PROPOSAL, CONTRACT, BOND AND SPECIFICATIONS

BARTILLON SHELTER

CONTRACT NO. 9358

BIDDER QUESTIONS, CLARIFICATIONS, AND REQUESTS FOR SUBSTITUTIONS:

A1.1B

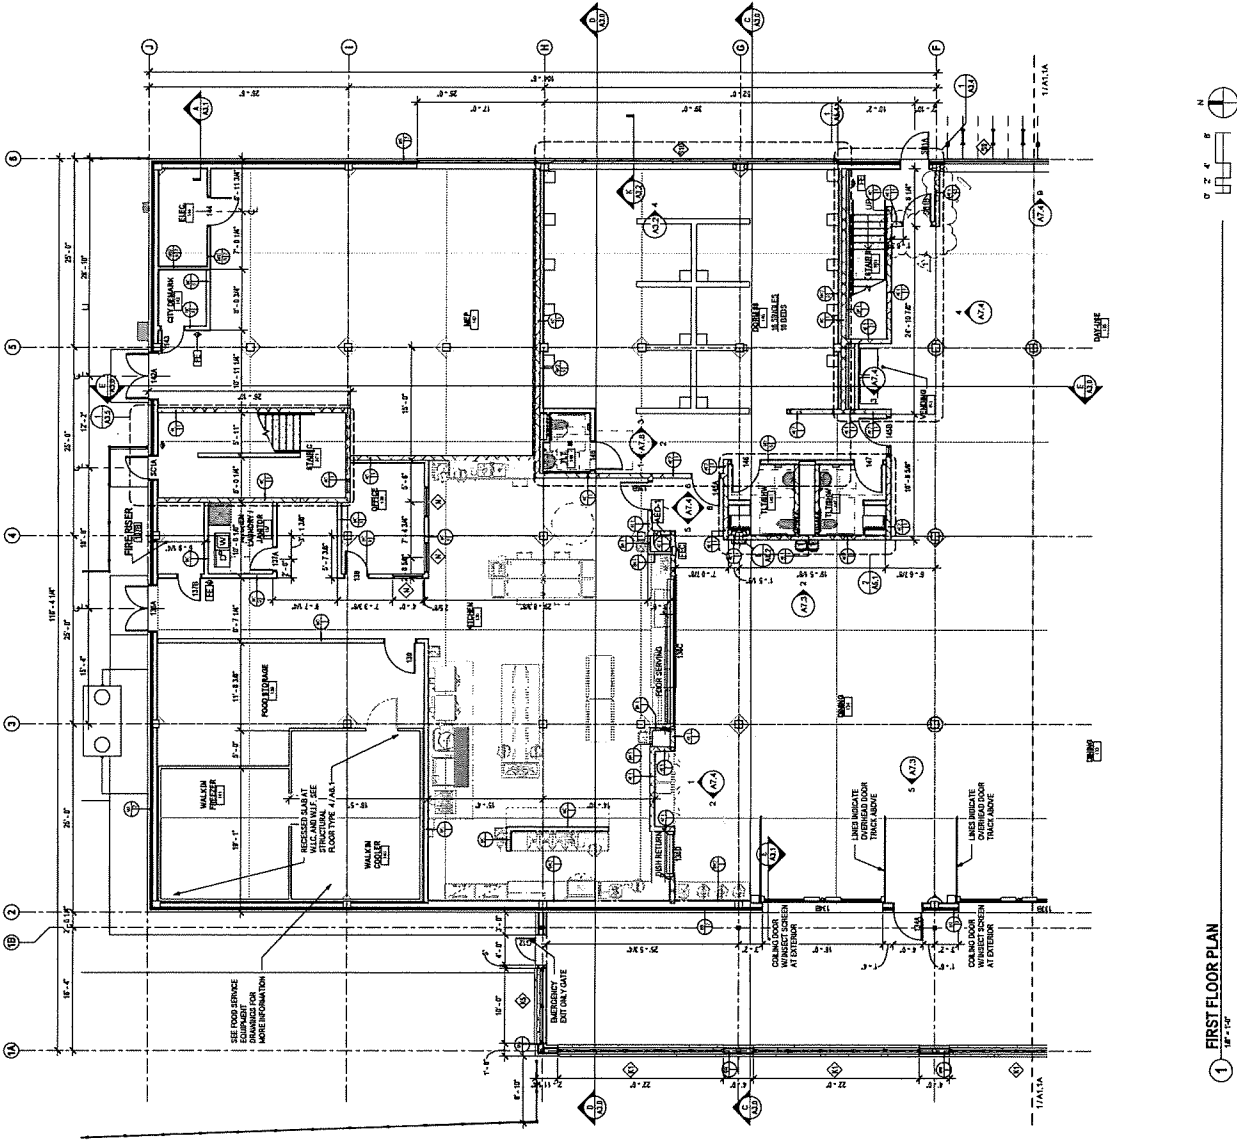
7. A1.1 – Overall Floorplan
 - a. First Floor Plan
 - i. Move Door SB1B and adjacent wall south 4”
 - ii. Add note “Provide paint at patio floor to delineate smoking area”

C 400

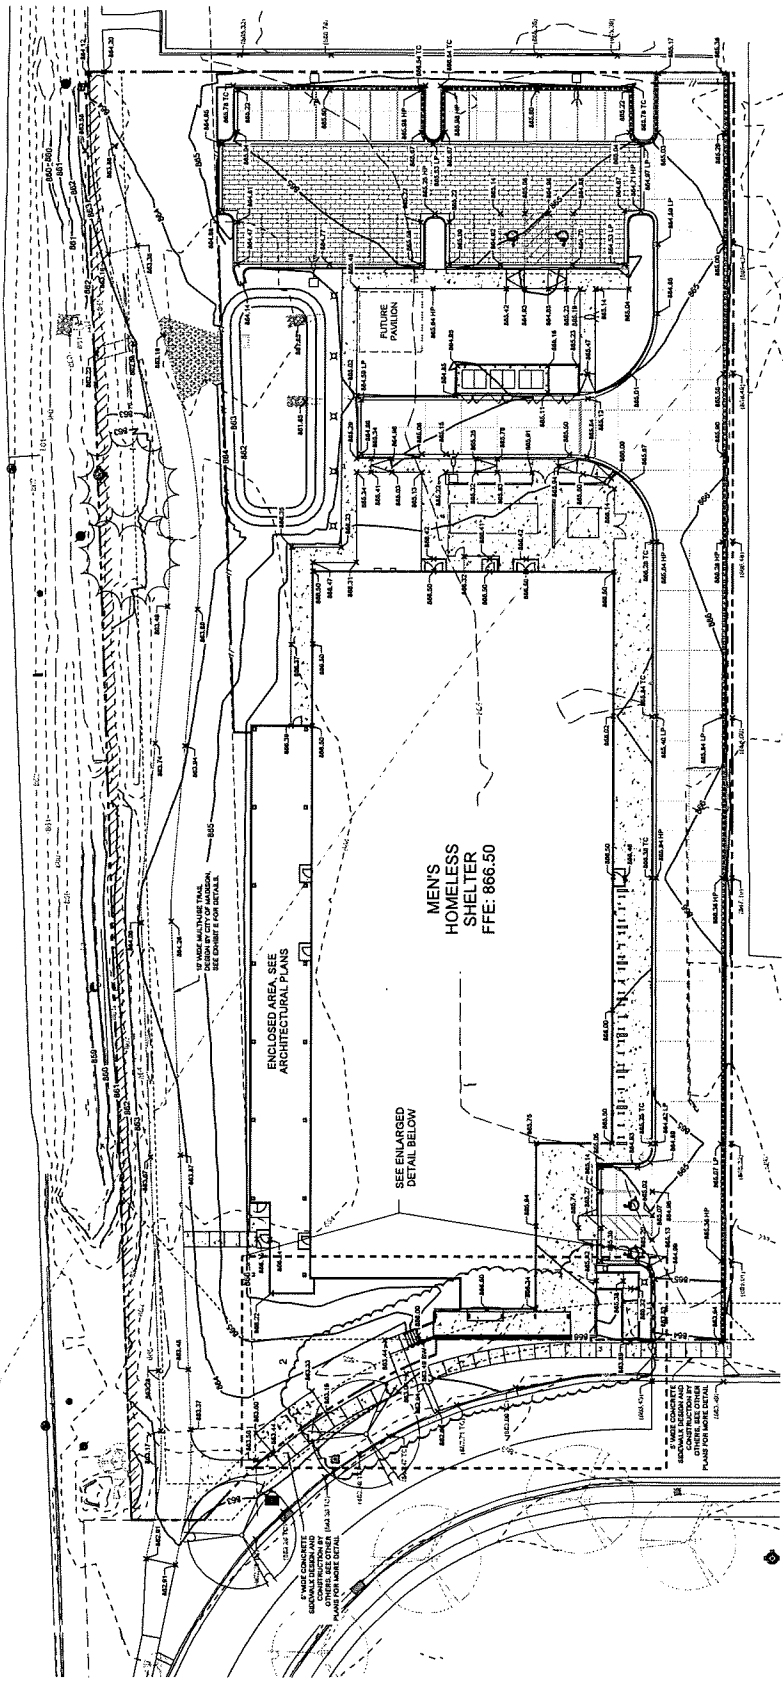
42. Please provide more detail for the site concrete directly east of the work depicted in 1/AS1.2 and drawing C400 at the enlarged front entry detail. Need additional detail on wall/footing sizes.
Provide 8" concrete wall with W30 footing 4'-0" below finished grade with #6 bars at 12" OC E/W centered; drawing S1.1A to be updated in forthcoming Addendum 3.

S1.1A

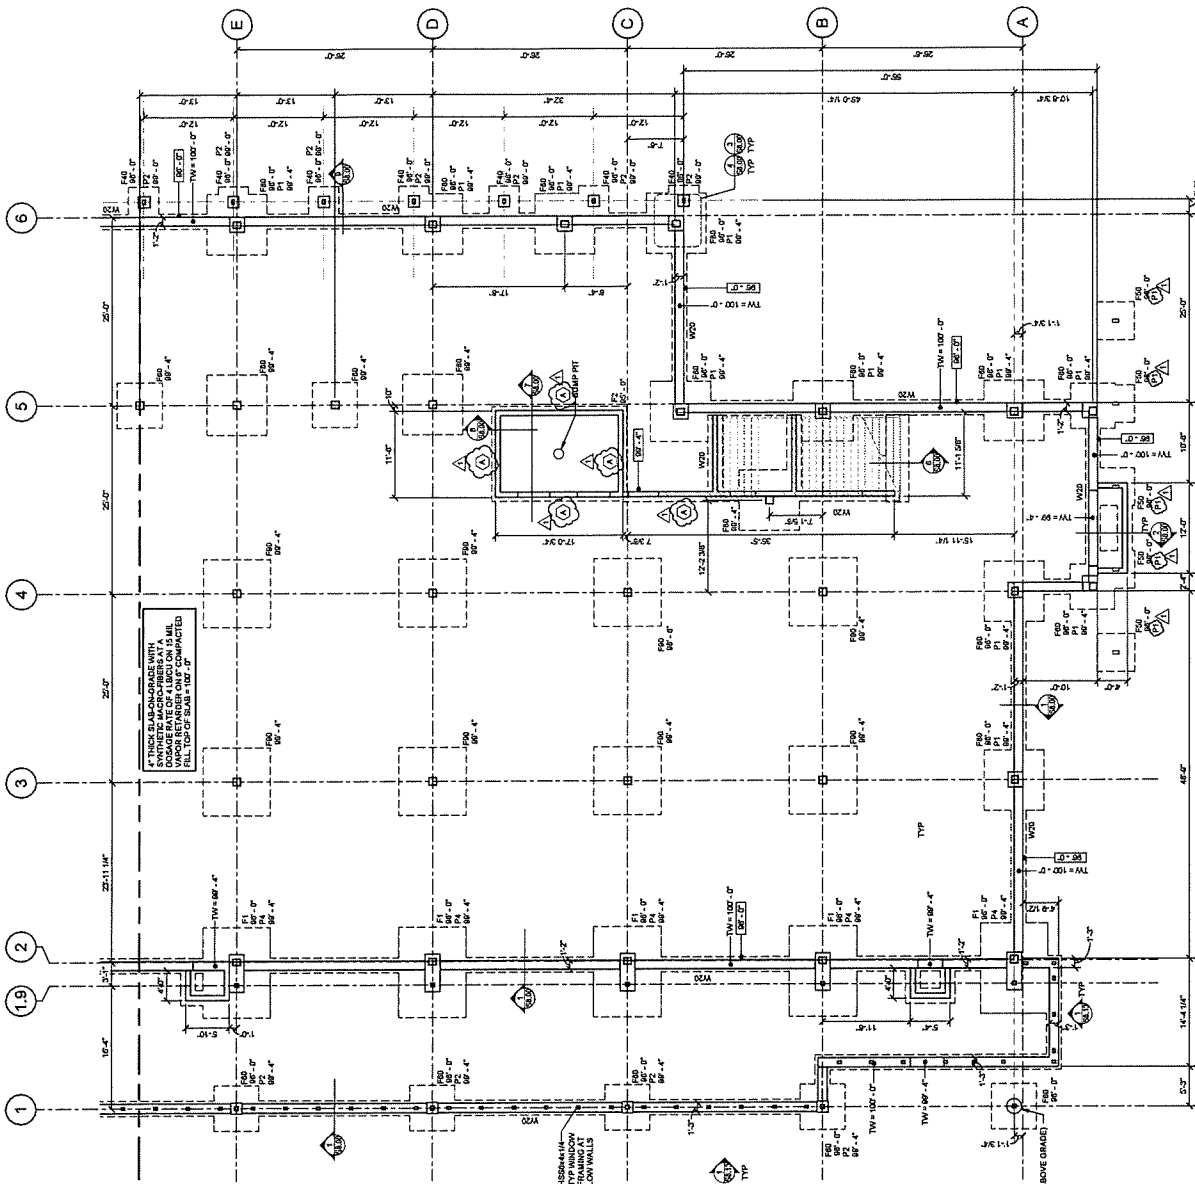
29. Sheet S1.1A references an elevation 1/S8.13; however, sheet S8.13 has not been issued. Please issue this sheet.
Sheet S8.13 is issued in Addendum 2.

S1.2A

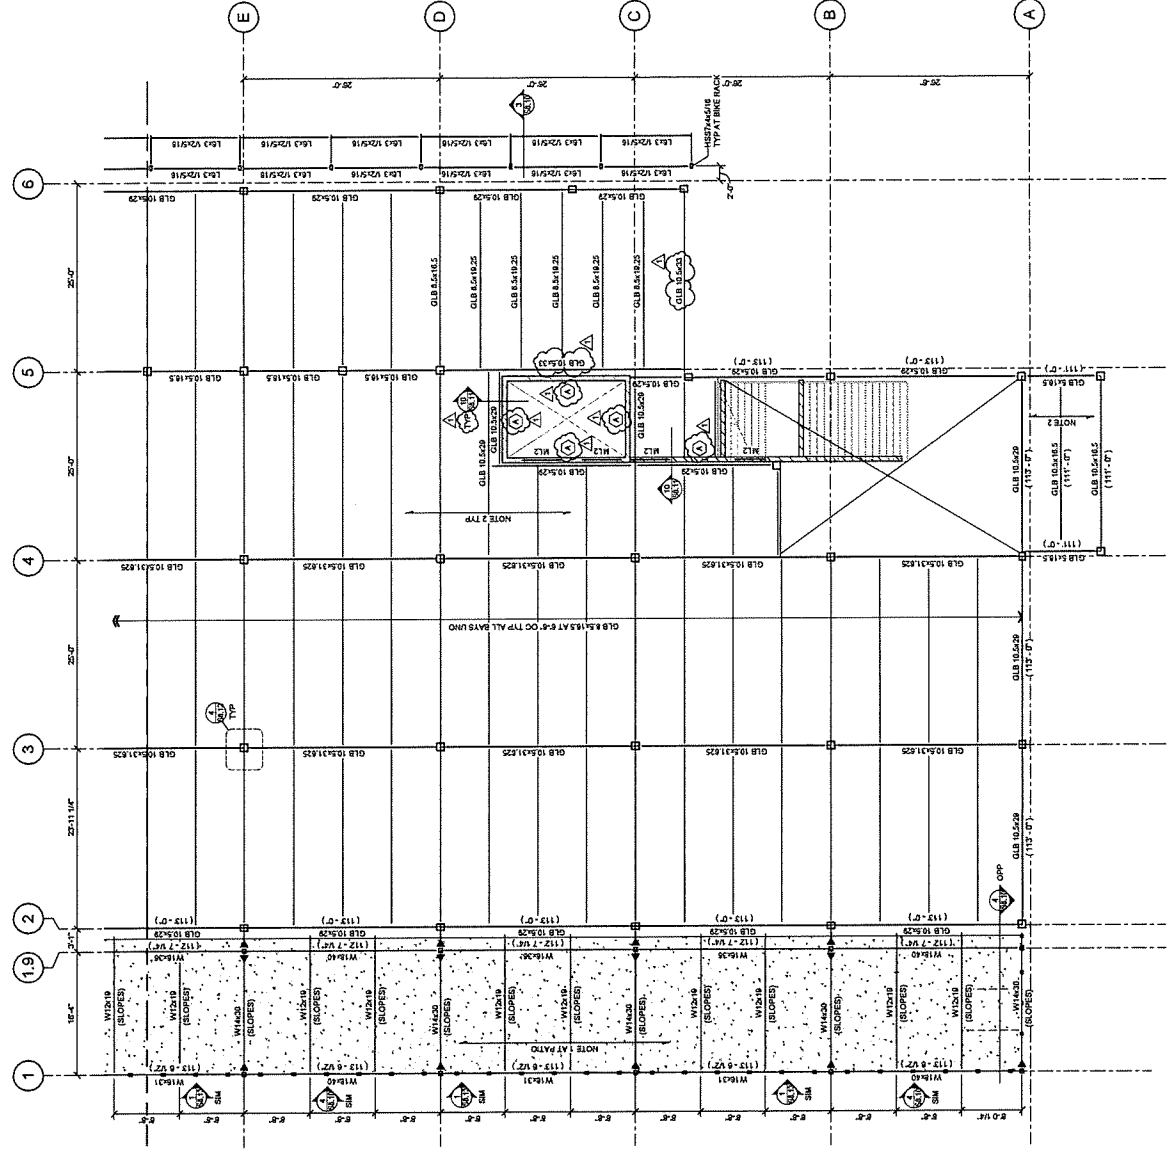
7. On drawing S1.2A there is a callout for section 1/S8.13; however, drawing S8.13 has been provided. Please provide drawing S8.13 or clarify the section reference.

Drawing S8.13 is added to set via Addendum 2.

S1.2B

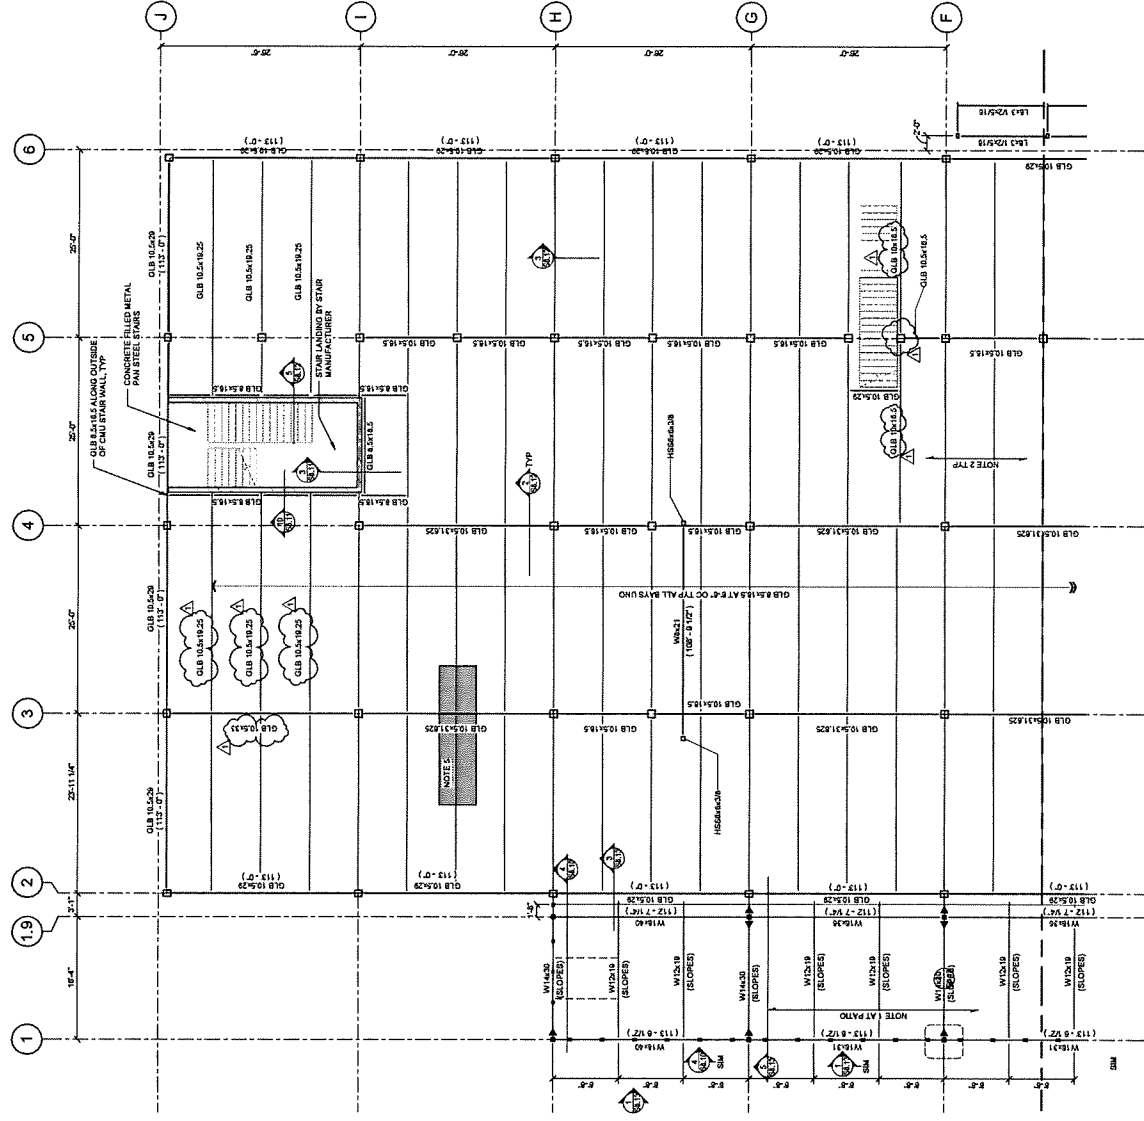
30. (BDS) Sheet S1.2B references a cross section 3/S8.13; however, sheet S8.13 has not been issued. Please issue this sheet.
Sheet S8.13 is issued in Addendum 2.

S1.1B

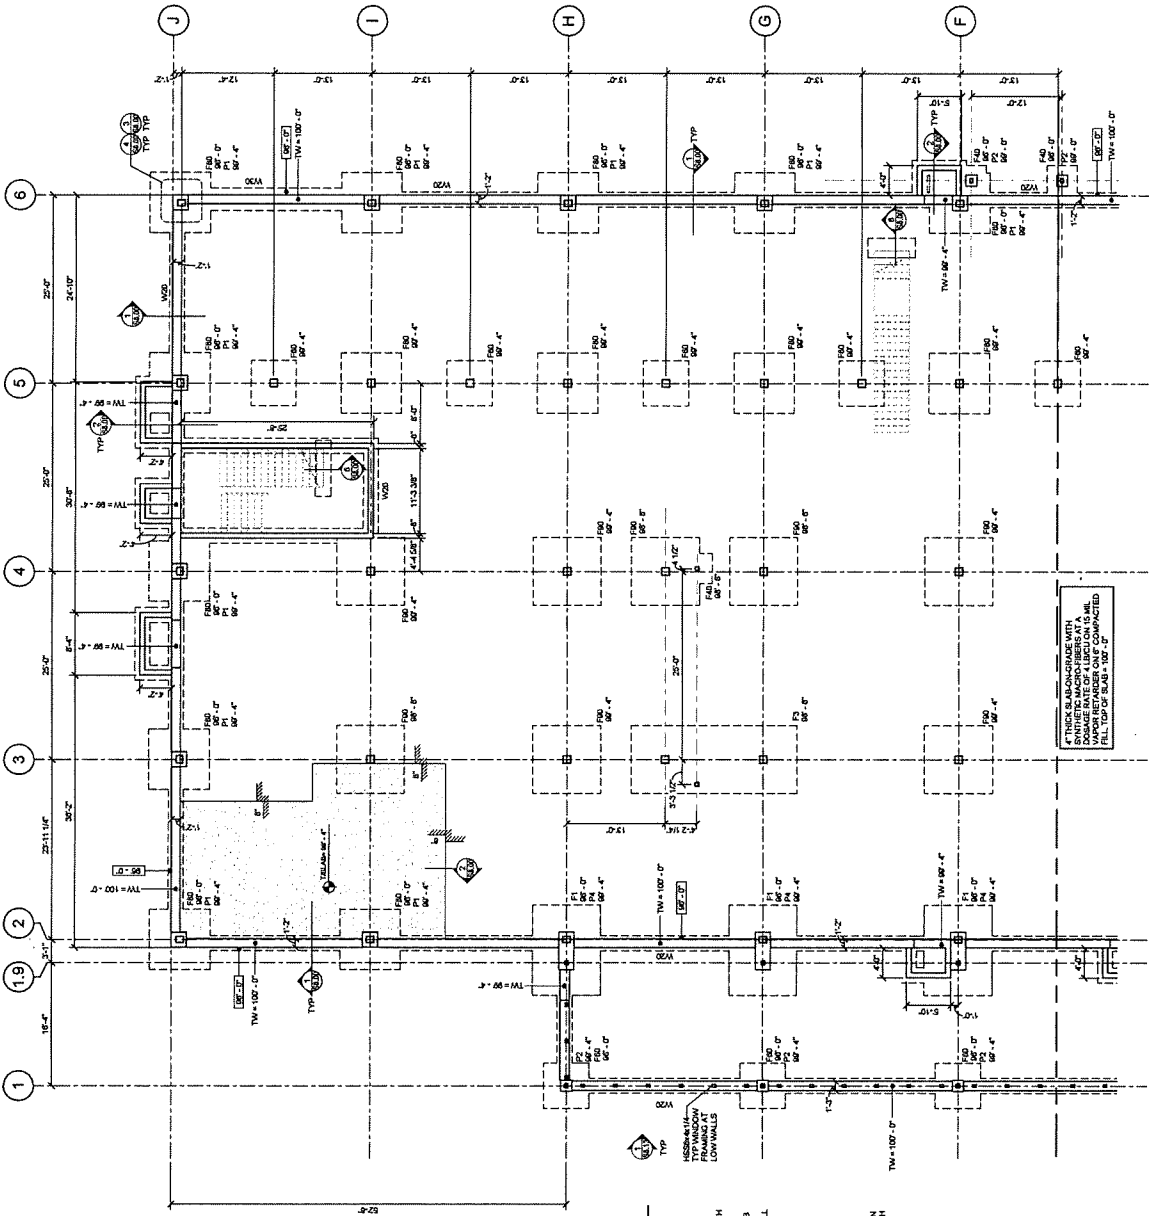
41. Sheet AS1.4 notes a 3B/2 concrete wall type separating the transformer & generator. No details for the wall/footings are shown. Please provide.
Please see revised sheet S1.1B Detail 2.

S1.3B

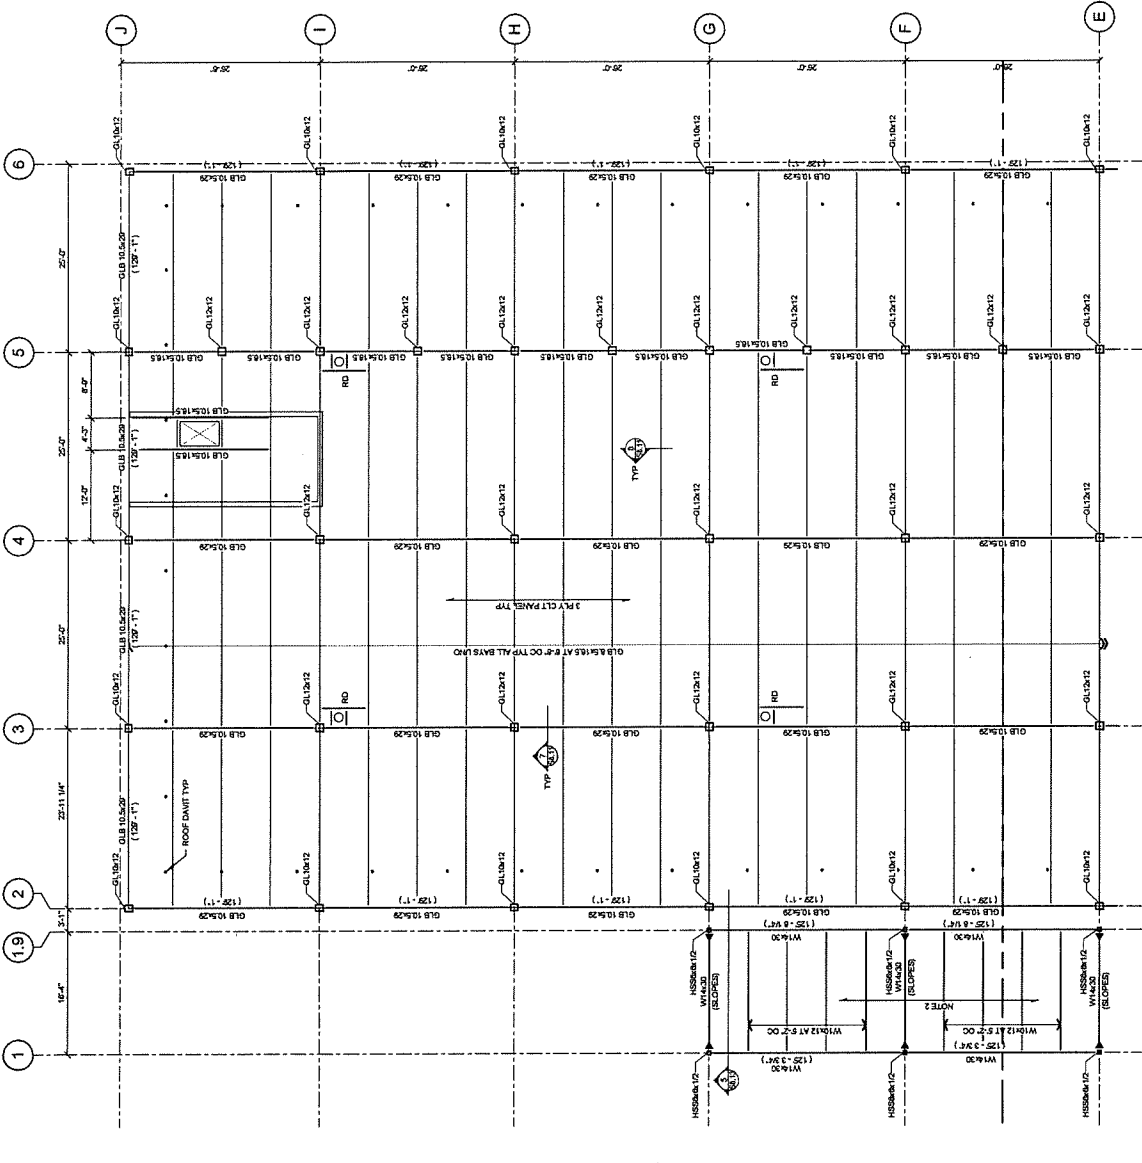
34. Please provide detail(s) at roof drains. What is the makeup of the framing materials shown on drawing S1.3B.
Beams at openings to be 3x6.875 glulam beams.

- 21. S1.3A – ROOF FRAMING PLAN – AREA A
 - i. Add detail reference to 10/S8.11
- 22. S1.3B – ROOF FRAMING PLAN – AREA B
 - i. Add detail reference to 10/S8.11
